# **BOGGABRI COAL**

## **Mod 7**

Submission of the Wando Conservation and Cultural Centre Inc, Maules Creek

**April 2019**

Figure 5-1 Approved vertical limit of mining (Hansen Bailey, 2010)

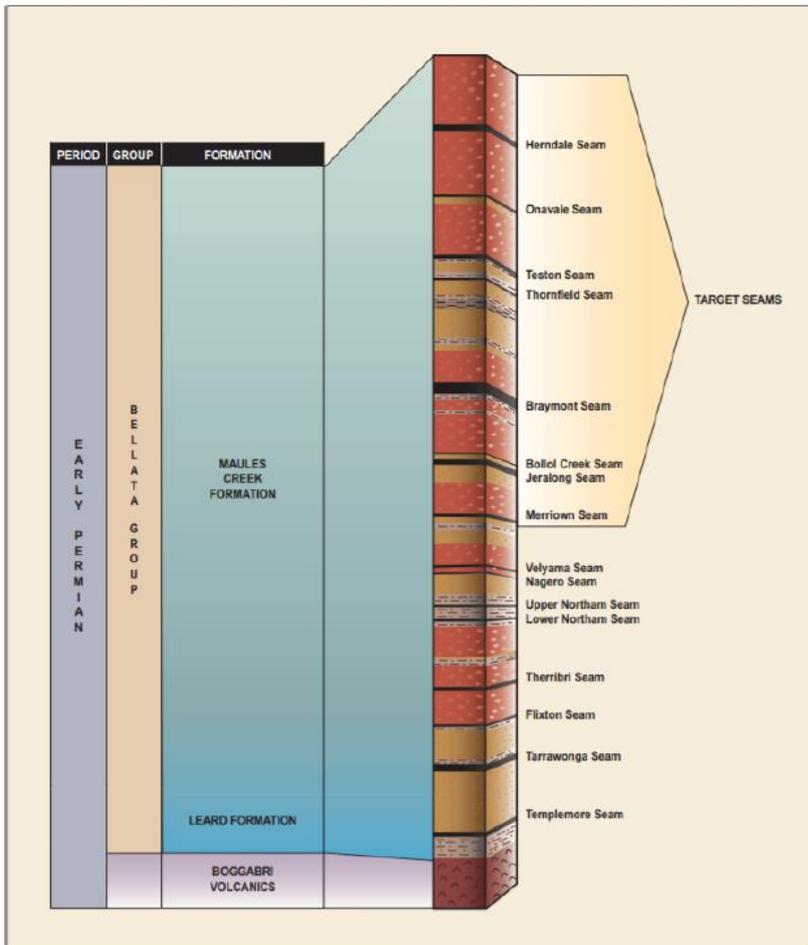
These extracts from the December 2018 MOP appear to explicitly state that the depth and quantity of proposed drilling extends beyond that which was assessed by Hansen Bailey in 2010.

The original 2010 Groundwater assessment (Australasian Goundwater and Environmental Consultants, 2010)<sup>1</sup> only assessed activities to the depth of the Merriown Seam. As such there is insufficient information or monitoring for any drilling beyond that depth.

Figure 5-2 Area of drilling 2017-21

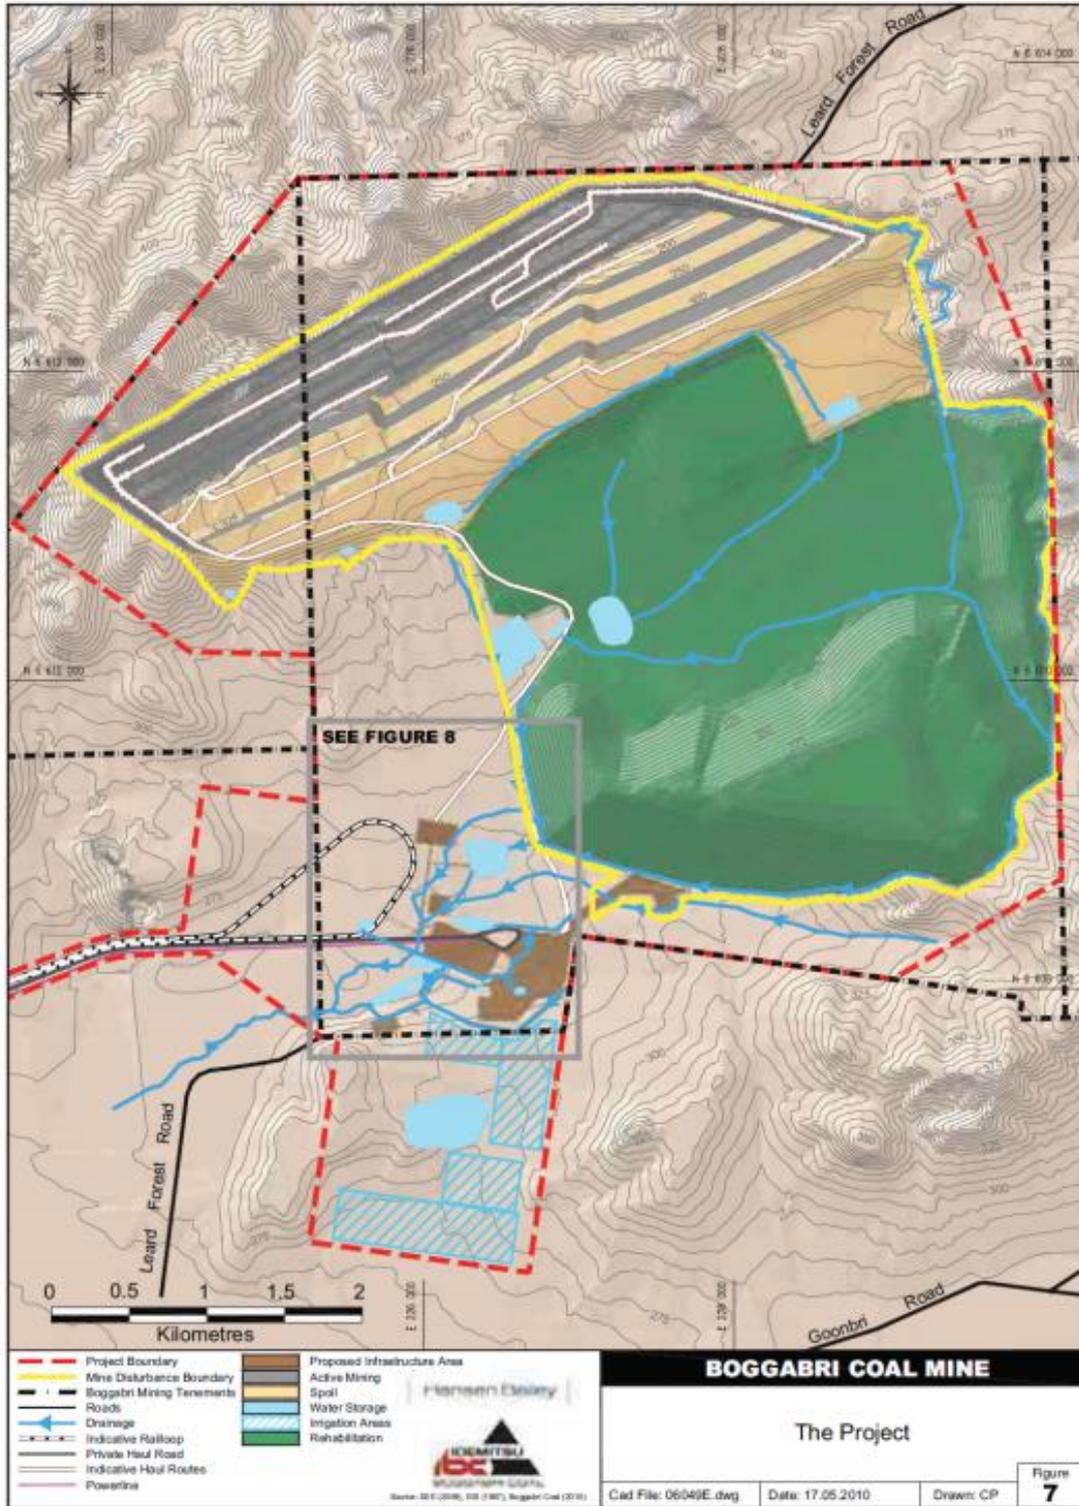
It is important to draw the Commissioners' attention to the fact that the proposed drilling area appears to overlap with the biodiversity offset corridor. This corridor is protected under the EPBC Approval. This protection occurred specifically to ensure a corridor for relevant protected species between Boggabri Mine and Maules Creek Mine. As such, this further suggests that the proposed modifications will result in significant environmental impact that requires proper assessment.

There are several ramifications of the fact that drilling and exploration is proposed outside of the Approved Disturbance Area. Potential impacts of drilling outside the mine disturbance area include:

- (i) Breach of the existing EPBC Conditions
- (ii) Being outside the Approved Mine Disturbance Boundary and Federal Approval Limit. As such, consideration should be given to the need for Mod 7 to be referred to the Commonwealth under the EPBC Act, including by reference to ss 24D or s 24E of the EPBC Act.
- (iii) Aboriginal Impact Assessment shows that the area outside the Approved Mine Disturbance Boundary which is to be subject to drilling is also the location of artefacts NV5 and NV14, and calls for fresh consultation with the Gomeroi Traditional owners.
